Project Name	30 Fairlight St, Fairlight	Project Number	00012781
Project Address	30 Fairlight St, Fairlight, NSW 2094	Drawing Name	Basement Plan
		Scale	1:150, 1:1 (A3)
		Date	August 2023
Client	Adjani Pty Ltd	Drawing Number	DA200
		Revision	I

**MOD2023/0479**

**SCHEDULE OF CHANGES**

PROJECT  
Residential Development  
30 Fairlight street,  
FAIRLIGHT, NSW

DRAWING TITLE  
LANDSCAPE PLAN  
BASEMENT

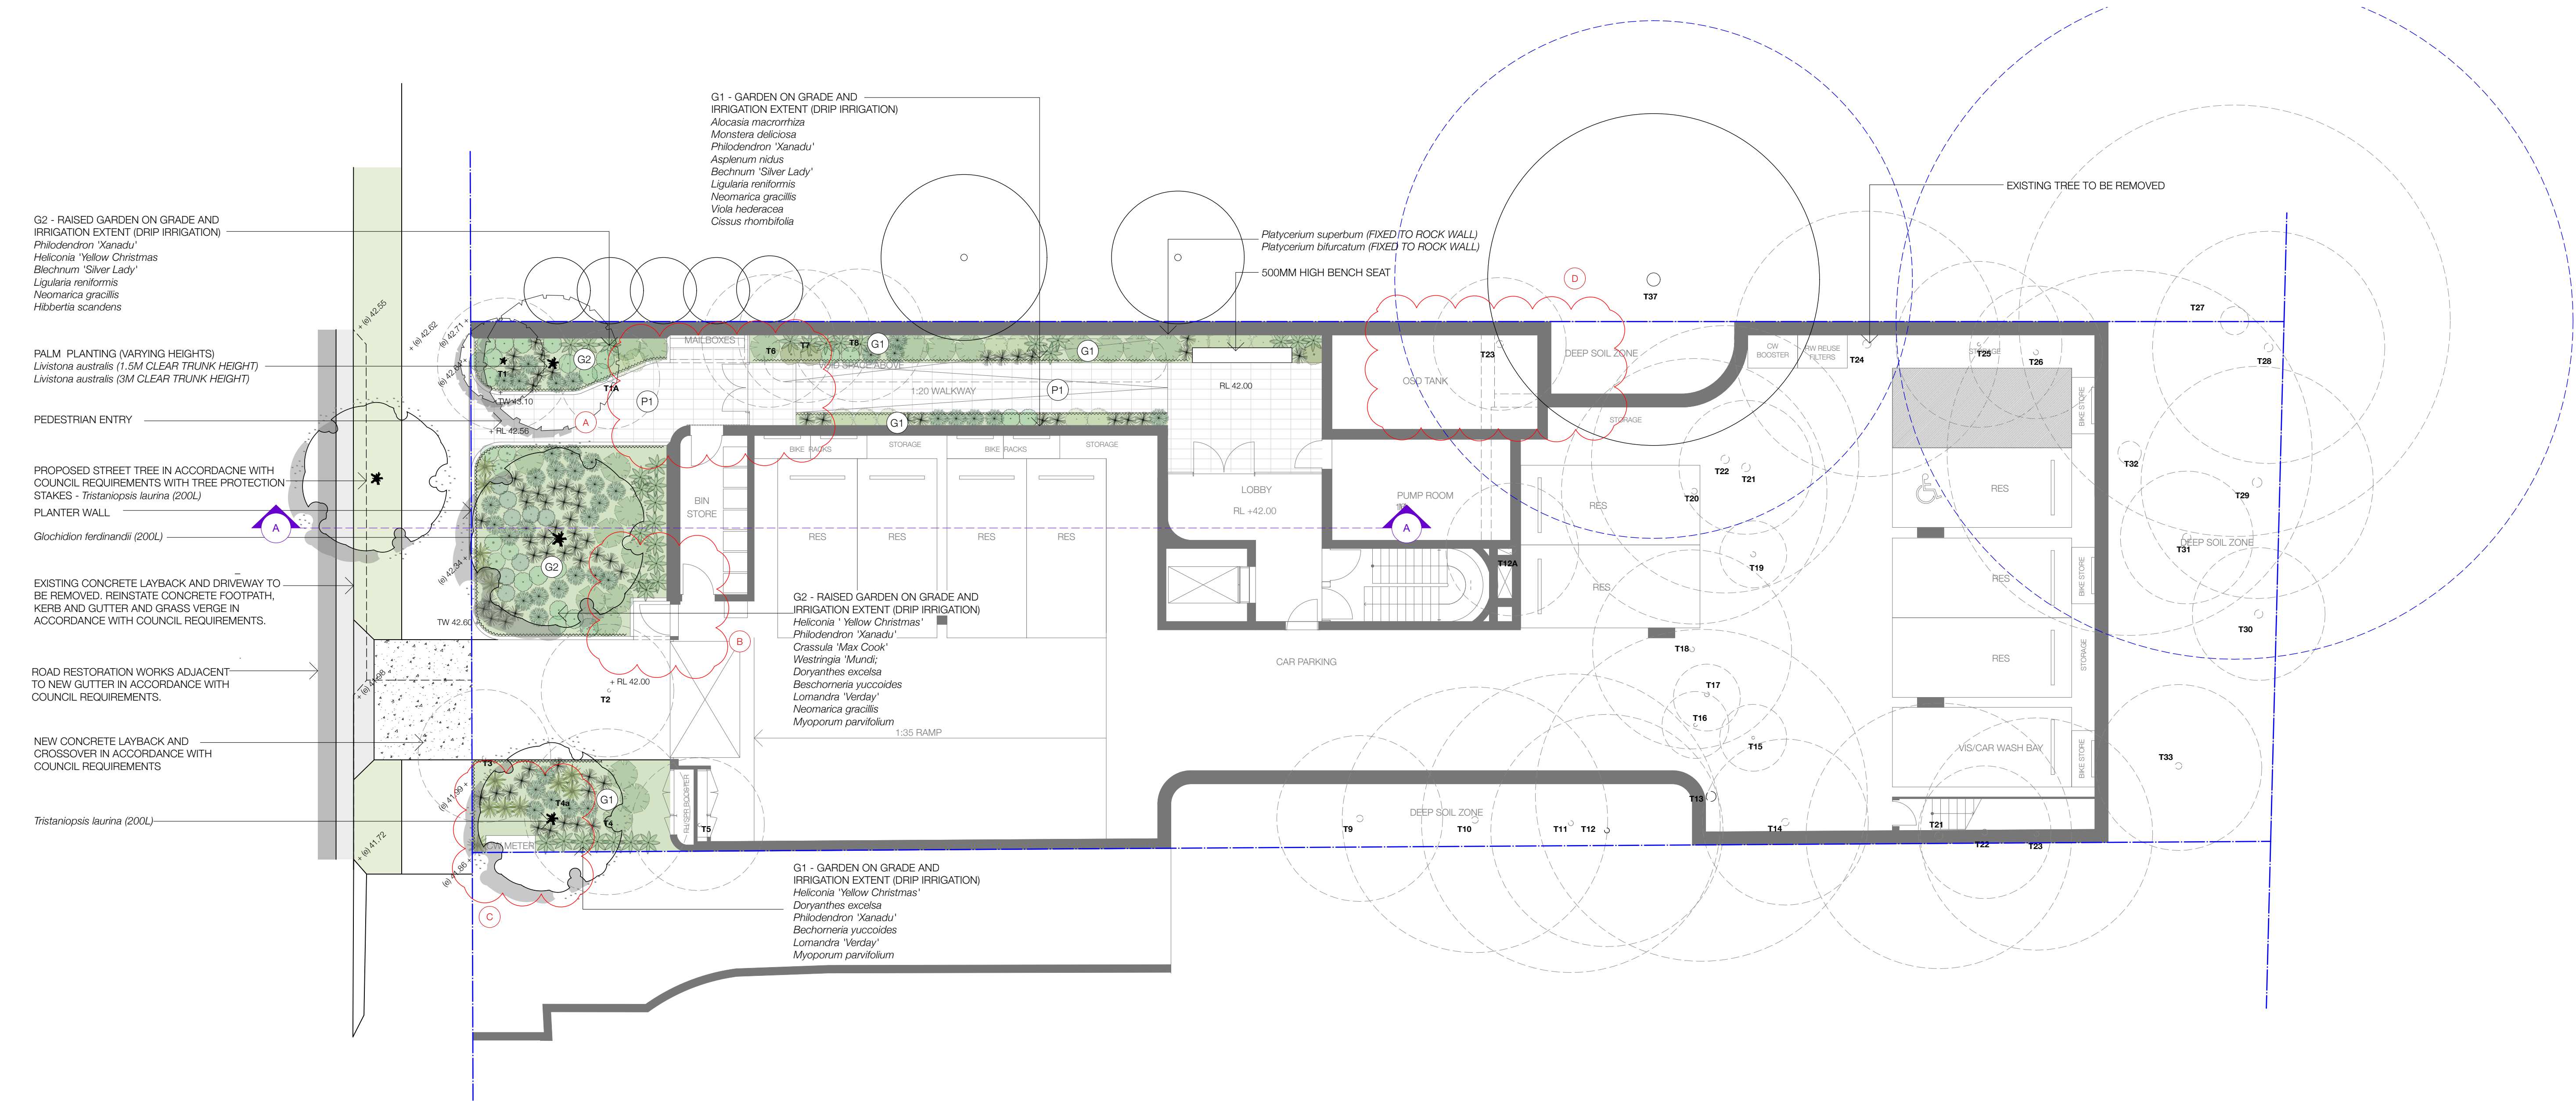
- AMENDMENTS
- A. PLANTER AND DEEPSOIL REDUCED TO ACCOMMODATE RELOCATION OF MAILBOX FOR DDA COMPLIANCE.
- B. ADDITIONAL DOOR ADDED AND DEEP SOIL REDUCED TO ALLOW FOR COMPLIANCE AS ALTERNATE FIRE EGRESS WITH NCC D2D6
- C. REVISED LANDSCAPING ARRANGEMENT TO ACCOMMODATE RELOCATED CW METER
- D. OSD TANK EXTENDED TO ACCOMMODATE MINIMUM VOLUME AS PER STORMWATER ENGINEER'S REPORT.
- E. WALL OF FRONT TERRACE RATIONALISED FOR BUILDABILITY - REVISED LANDSCAPE
- F. COURTYARD LANDSCAPE AMENDMENT, REVISED LANDSCAPE EXTENT
- G. REVISED LANDSCAPE AREAS

LANDSCAPE PLAN  
GROUND FLOOR

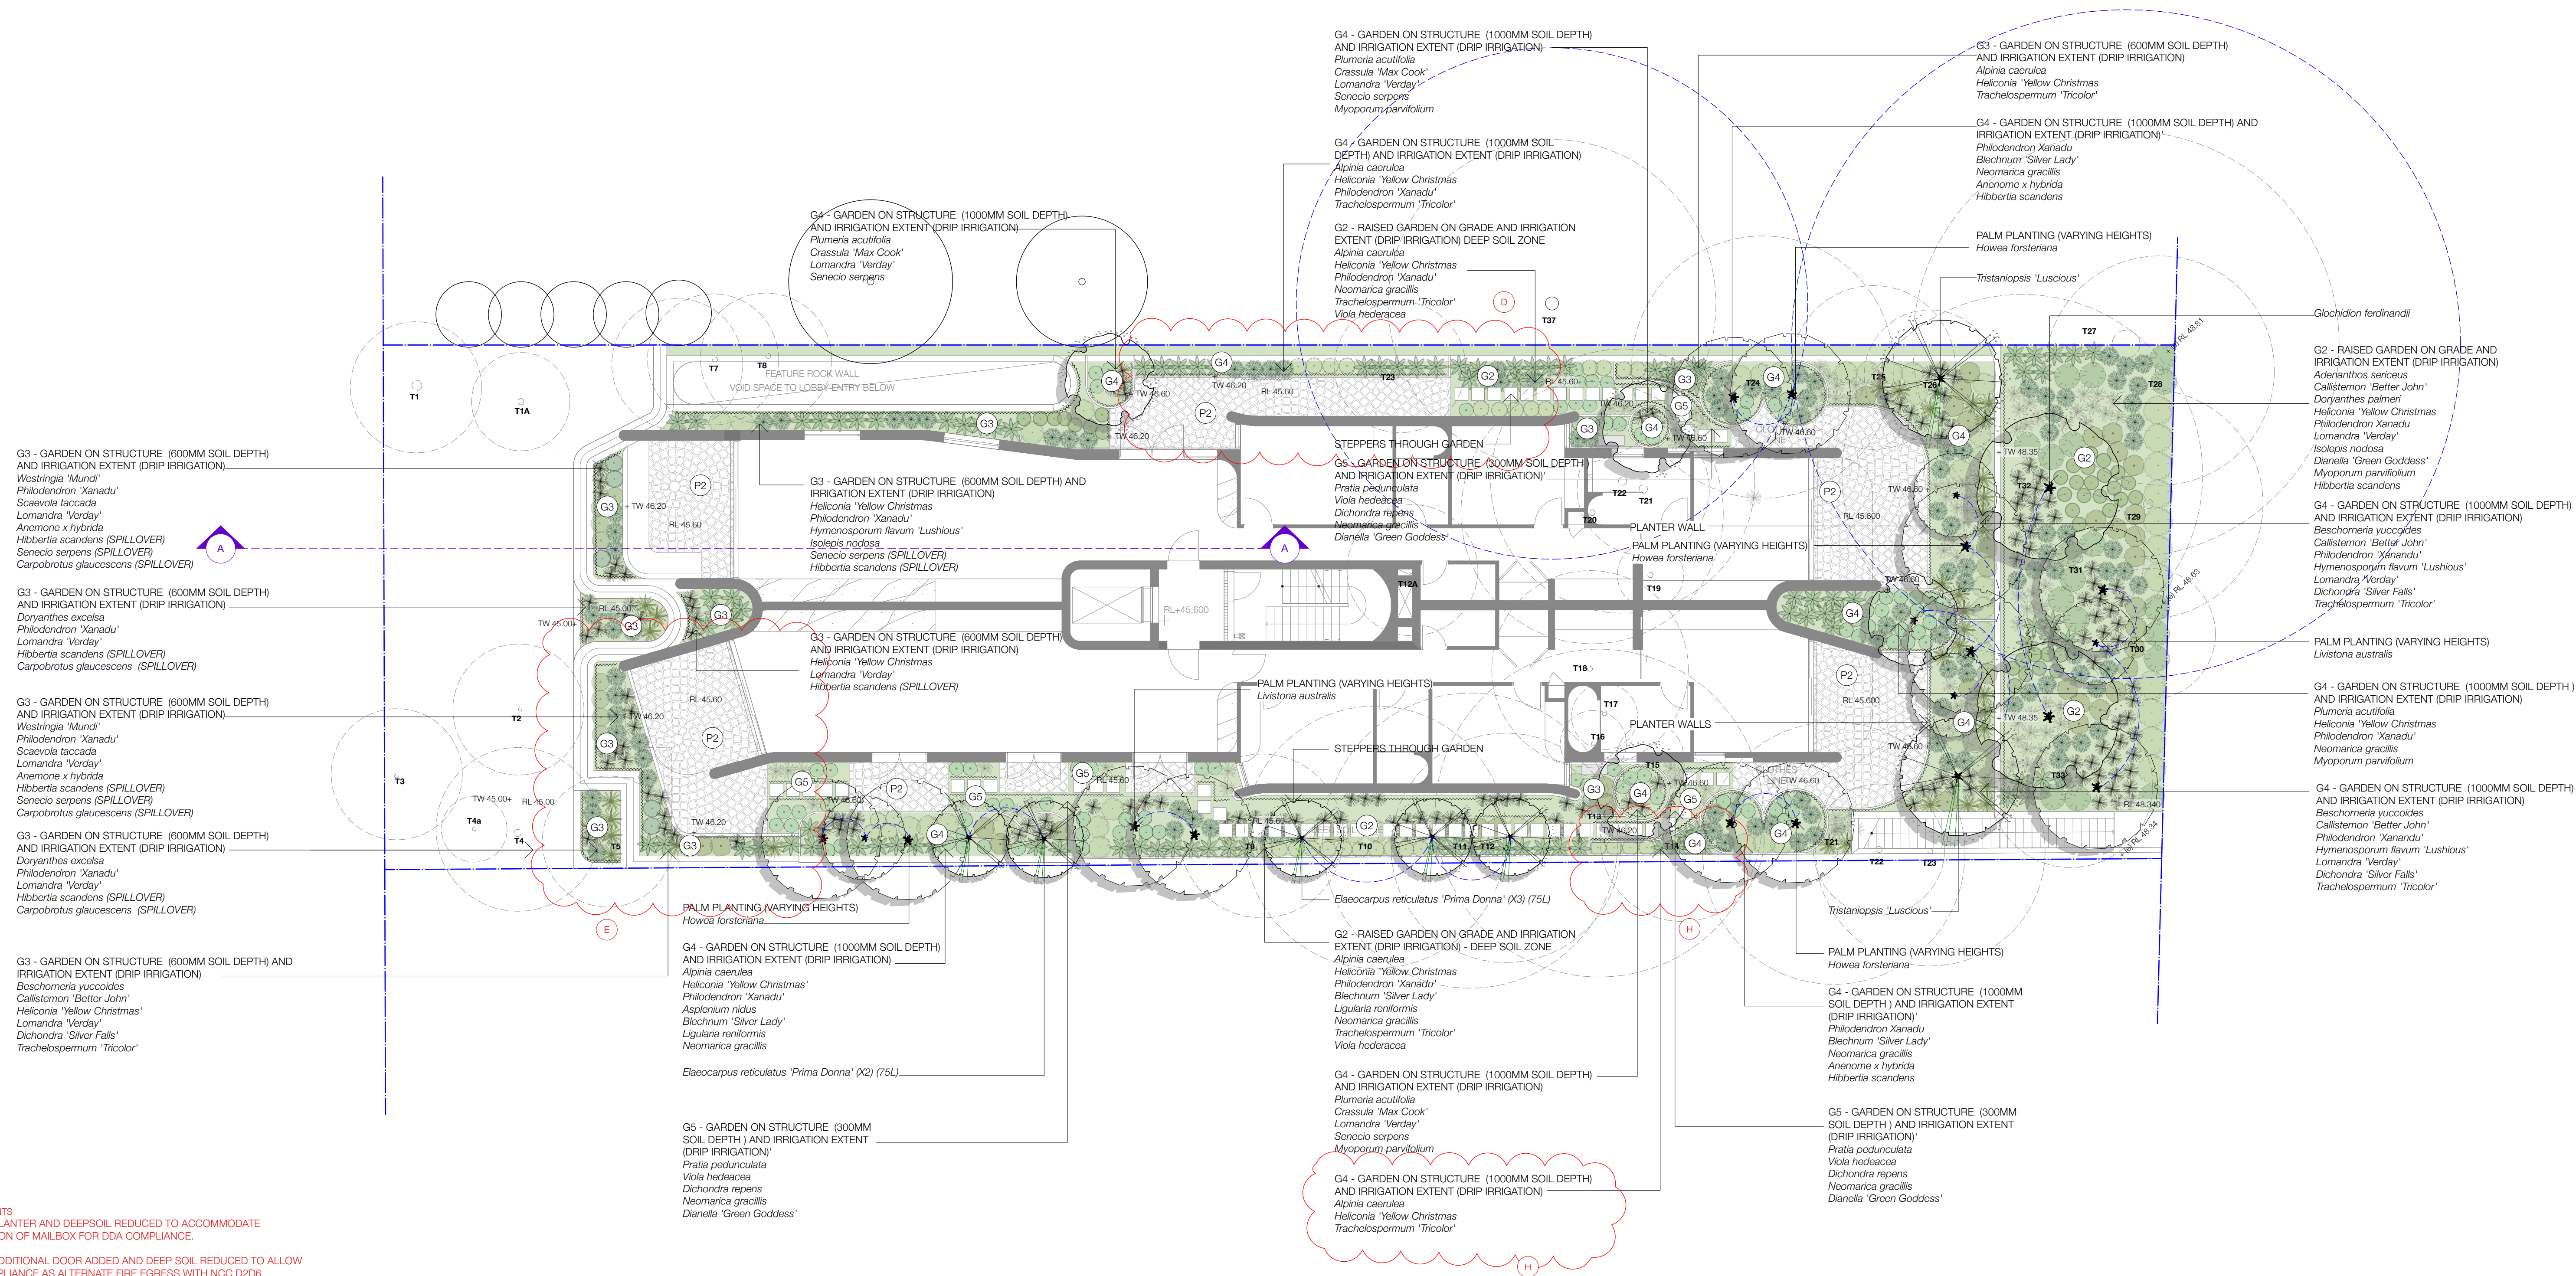
- A. PLANTER AND DEEPSOIL REDUCED TO ACCOMMODATE RELOCATION OF MAILBOX FOR DDA COMPLIANCE.
- B. ADDITIONAL DOOR ADDED AND DEEP SOIL REDUCED TO ALLOW FOR COMPLIANCE AS ALTERNATE FIRE EGRESS WITH NCC D2D6
- C. REVISED LANDSCAPING ARRANGEMENT TO ACCOMMODATE RELOCATED CW METER
- D. OSD TANK EXTENDED TO ACCOMMODATE MINIMUM VOLUME AS PER STORMWATER ENGINEER'S REPORT.
- E. WALL OF FRONT TERRACE RATIONALISED FOR BUILDABILITY - REVISED LANDSCAPE
- F. COURTYARD LANDSCAPE AMENDMENT, REVISED LANDSCAPE EXTENT
- G. REVISED LANDSCAPE AREAS
- H. REVISED SOIL DEPTH

**DRAWING TITLE**  
**LANDSCAPE PLAN**  
**LEVEL01 & LEVEL 02**

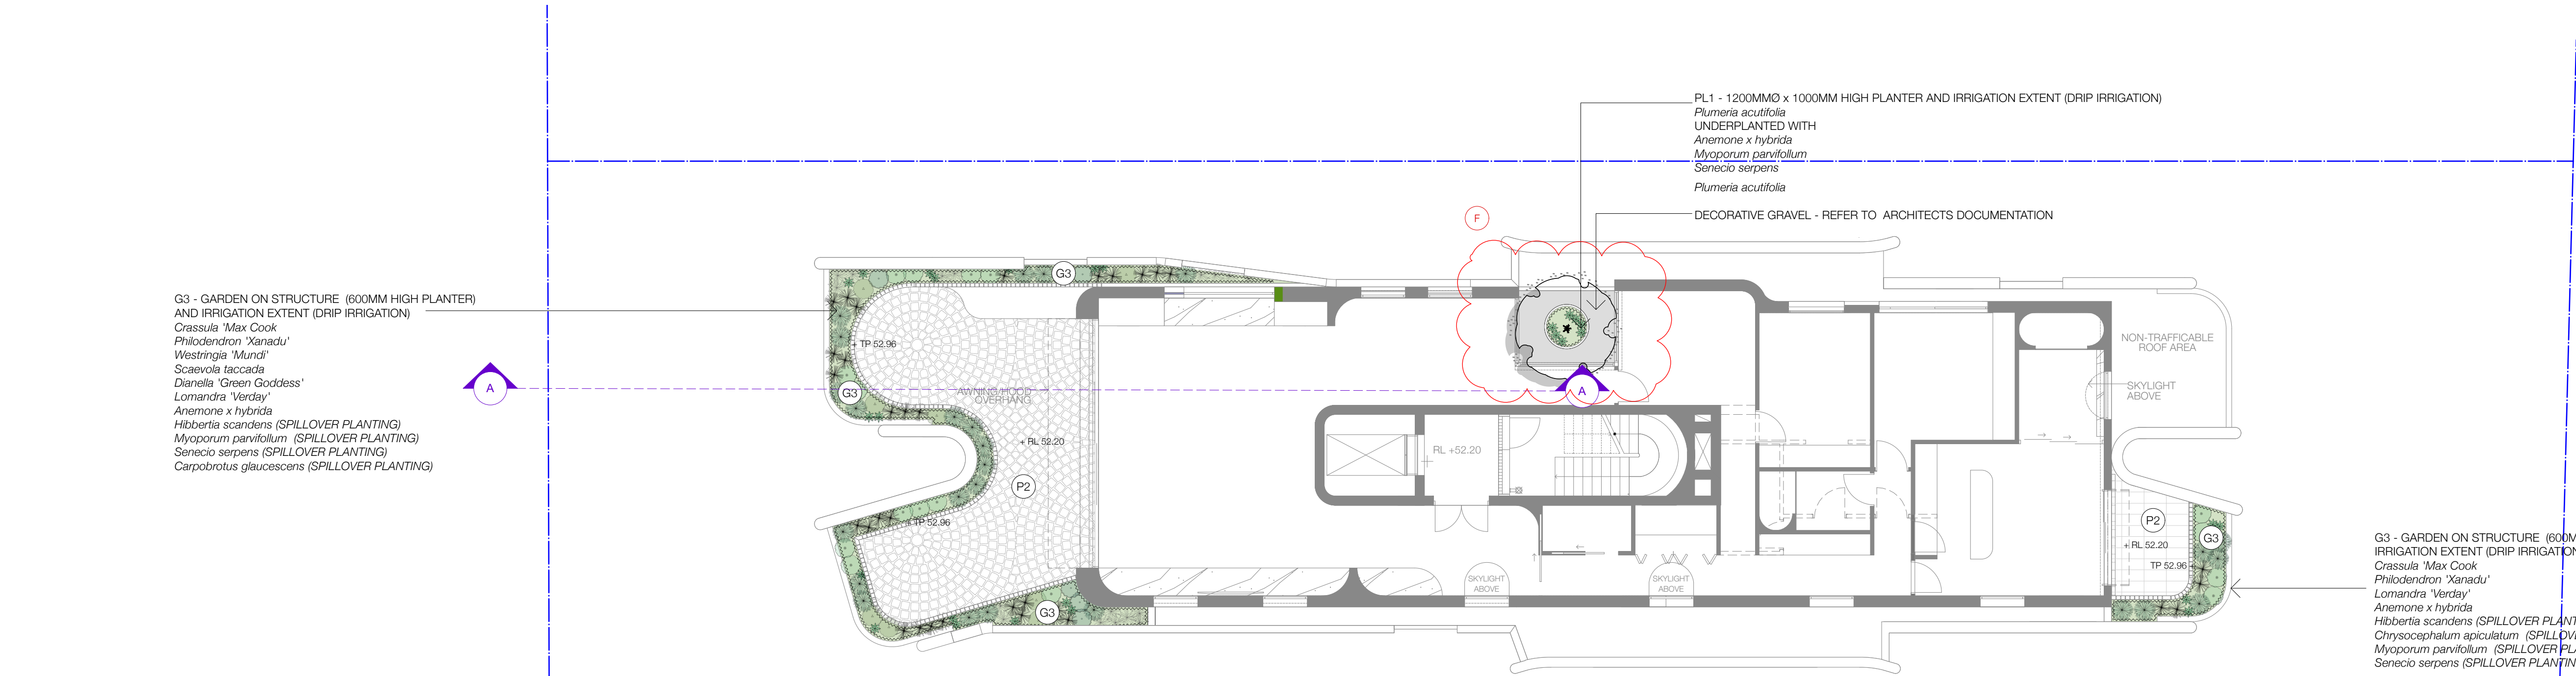
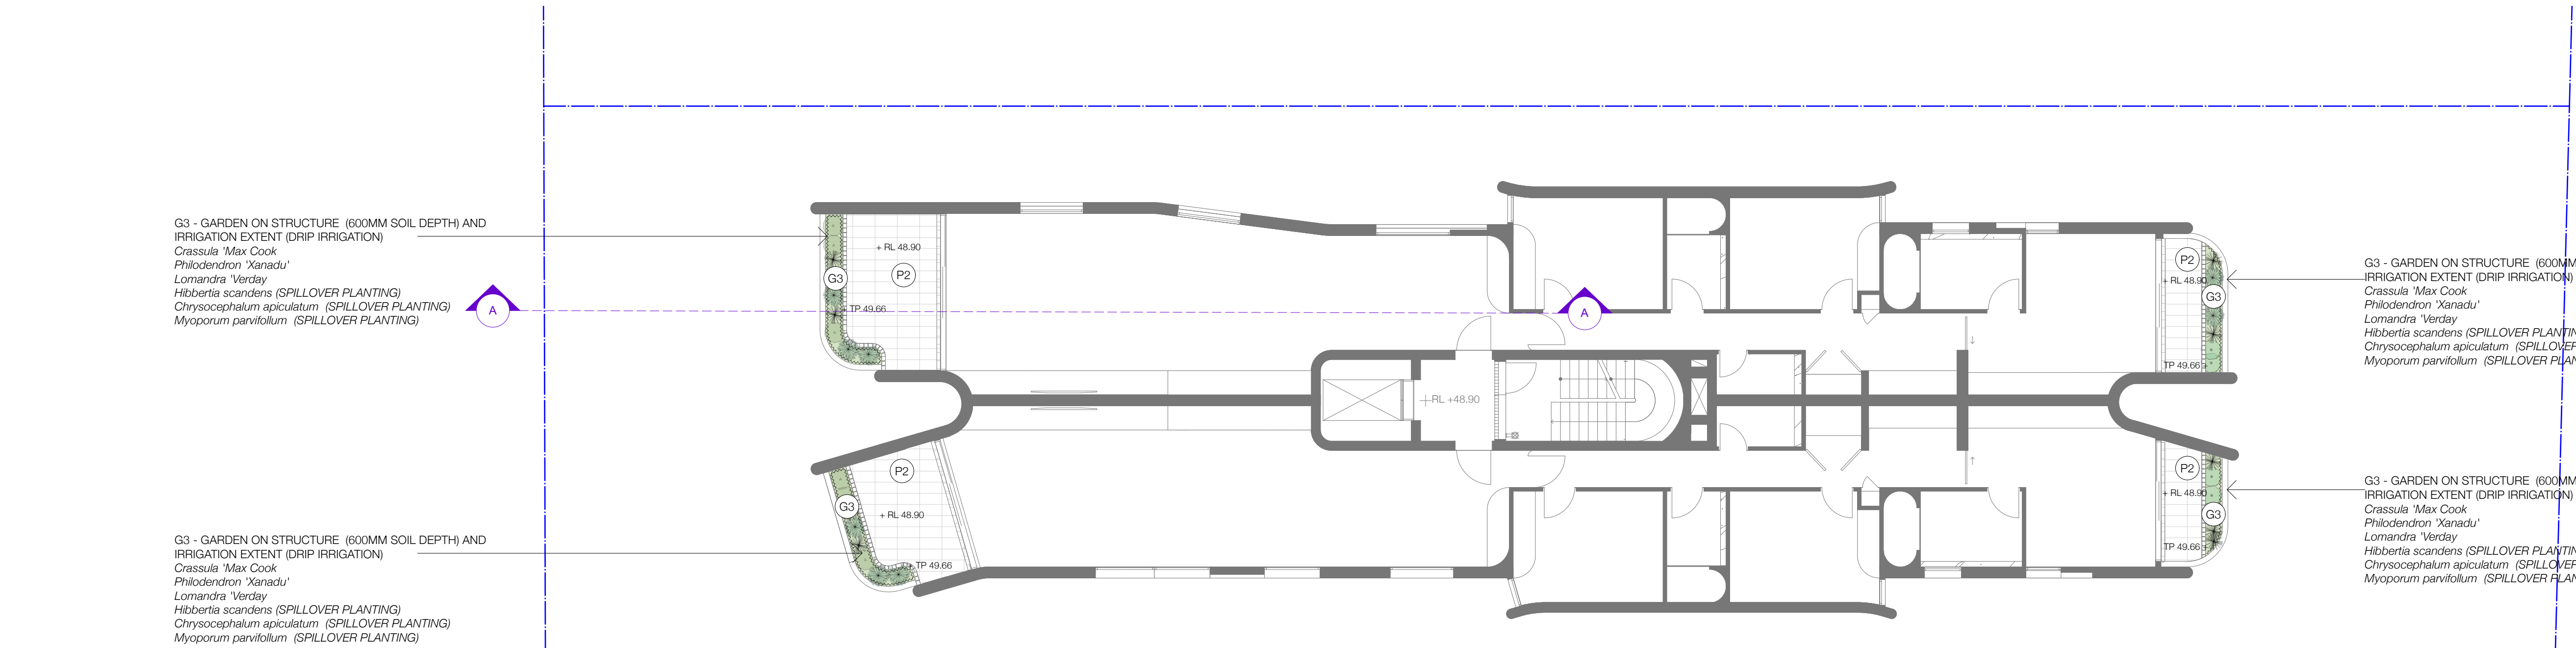
- AMENDMENTS
- A. PLANTER AND DEEPSOIL REDUCED TO ACCOMMODATE RELOCATION OF MAILBOX FOR DDA COMPLIANCE.
- B. ADDITIONAL DOOR ADDED AND DEEP SOIL REDUCED TO ALLOW FOR COMPLIANCE AS ALTERNATE FIRE EGRESS WITH NCC D2D6
- C. REVISED LANDSCAPING ARRANGEMENT TO ACCOMMODATE RELOCATED CW METER
- D. OSD TANK EXTENDED TO ACCOMMODATE MINIMUM VOLUME AS PER STORMWATER ENGINEER'S REPORT.
- E. WALL OF FRONT TERRACE RATIONALISED FOR BUILDABILITY - REVISED LANDSCAPE
- F. COURTYARD LANDSCAPE AMENDMENT, REVISED LANDSCAPE EXTENT
- G. REVISED LANDSCAPE AREAS
